Subject: Moab Uranium Mill Tailings Remedial Action (UMTRA) Project Remedial Action Plan

The Department of Energy (DOE) recently identified a discrepancy in the designed thickness of a portion of the cover as presented in the final Remedial Action Plan (RAP). The plan received conditional concurrence in July 2008. The discrepancy pertains to the thickness of the planned disposal cover over a 14-foot-wide section of the residual radioactive material (RRM) located on the eastern, western, and southern edges of the cover (See Figure 1).

Figure 2. Radon barrier at edge of cell as per E-02-C-501.

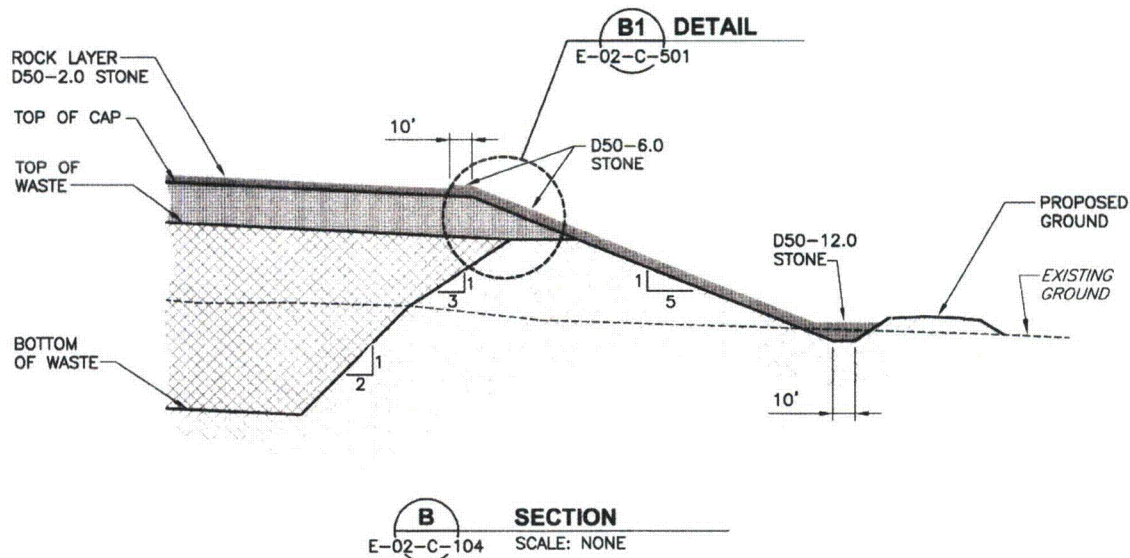
As designed, the sloping cell cover creates a section that is less than the intended full cover thickness as shown on drawing E-02-C-501 section B (see Figure 2).

Approximately 2,400 linear feet of RRM has been placed to the design elevation which when the cover materials are placed will have approximately 6 feet of total cover thickness rather than the intended 8.5 feet. In this area the frost protection layer would be reduced.

To evaluate the impact on radon emanation of the cell cover having a reduced thickness, the DOE has performed an evaluation of the radon emanation assuming a reduced frost protection layer. The evaluation showed that though the radon flux exceed the Nuclear Regulatory Commission (NRC) radon limit of 20 pCi/m²/sec in the area of concern, the overall average flux from the eventual completed cell did not change and is under the NRC limit.

Figure 3. Profile showing reduced RRM placement and additional interim cover.

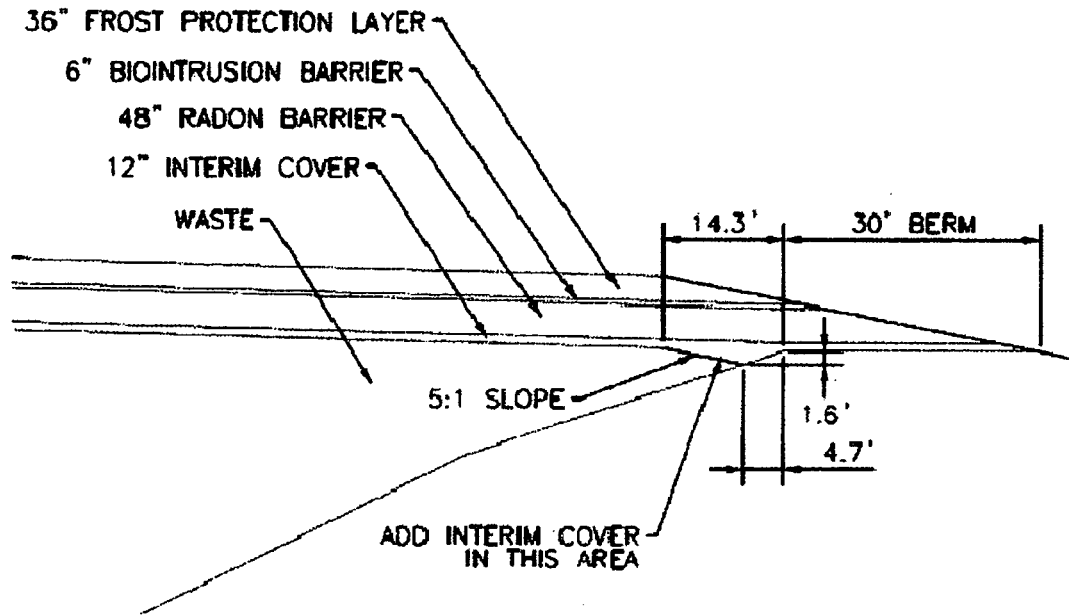
As a result, the DOE is requesting concurrence to leave the RRM already placed to the design elevation. As a best management practice, the DOE may reduce the thickness of RRM placed along the yet-to-be-filled portion of the cell, which would allow an associated increase in the thickness of the final cover to the design of 8.5 feet as shown in Figure 3. Along with this request, we would like to leave the existing drawing set in the RAP as submitted. Appropriate adjustment to the cell as-built drawings will be made and submitted with the completion report.
